UNITED STATES PATENT AND TRADEMARK OFFICE

APPLICATION NO.	FILING DATE	FIRST NAMED INVENTOR	ATTORNEY DOCKET NO.	CONFIRMATION NO.
10/724,966	12/01/2003	Lee J. Brown	1612	3032
20676	7590	12/16/2005	EXAMINER	
ALFRED J MANGELS			ROBERTSON, TIARA S	
4729 CORNELL ROAD			ART UNIT	
CINCINNATI, OH 452412433			PAPER NUMBER

Office Action Summary	Application No.	Applicant(s)	
	10/724,966	BROWN, LEE J.	
	Examiner	Art Unit	
	Tiara S. Robertson	3635

DETAILED ACTION

H. EEFINK.
EAVES TROUGH HANGER.
APPLICATION FILED MAR. 23, 1921.

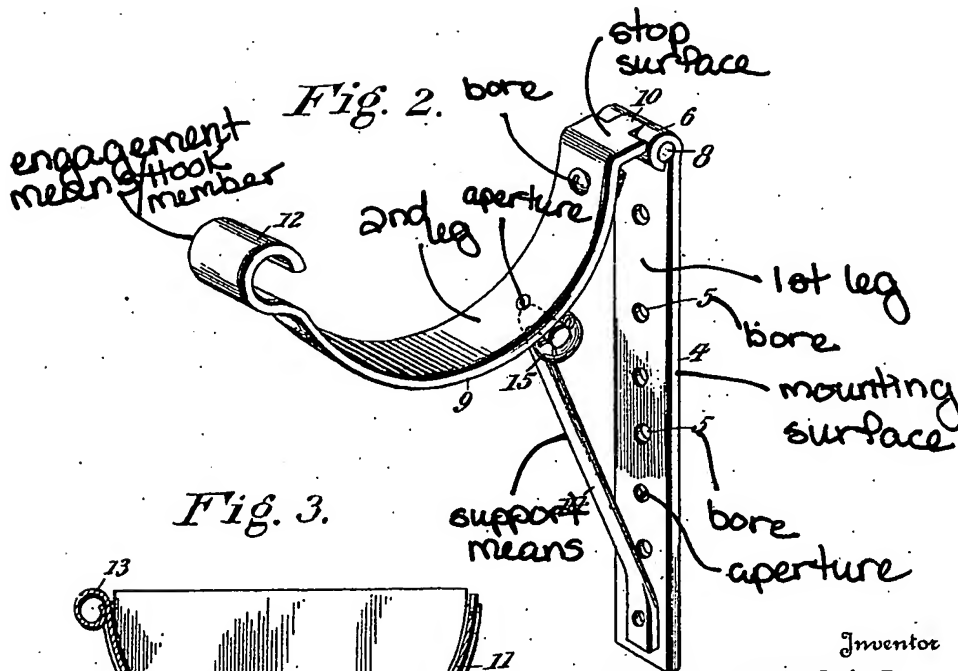
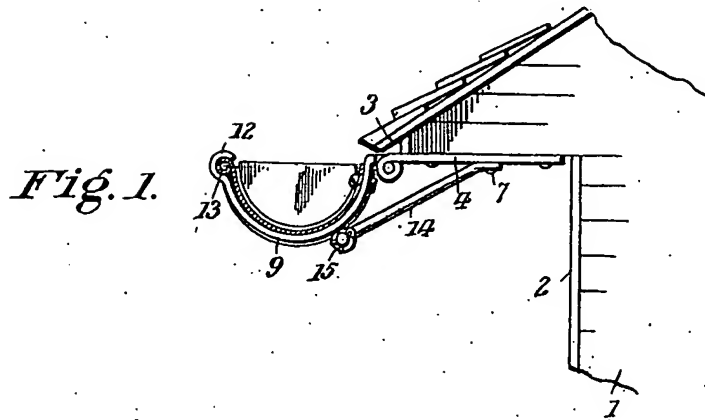
Regarding claim 1, Eeftink discloses a support with a substantially L-shaped body, including a first leg oriented vertically and a second leg oriented horizontally; the first leg including a mounting surface; at least one bore extending through the first leg toward the mounting surface and aligned with the second leg; at least one second bore extending into the second leg; engagement means carried by the second leg and support means carried by the first leg (see attached drawing).

Regarding claims 2 and 4, Eeftink discloses a bracket as describe in claim 1 where the first leg includes at least two fist bores and where the engagement means is a hook member (see attached drawing).

Regarding claims 5-7, Eeftink discloses a bracket as described in claim 1 and where, when the bracket as shown is rotated 180°, the support means is a surface inclined in a downward direction from a plane defined by the mounting surface. Where

the support means is inclined at an angle ranging from 60° to about 80° relative to the mounting surface. Where the inclination angle is about 75° (see attached drawing).

Regarding claims 8 and 9, Eeftink discloses a bracket as described in claim 1 including a stop surface carried by the second leg and, when rotated 180°, is positioned below an opening of the at least one second bore (see attached drawing).

Regarding claims 10-13, Eeftink discloses a bracket as described in claim 1 including at least one aperture in the body bracket positioned in the first leg and at least one aperture positioned in the second leg (see attached drawing).
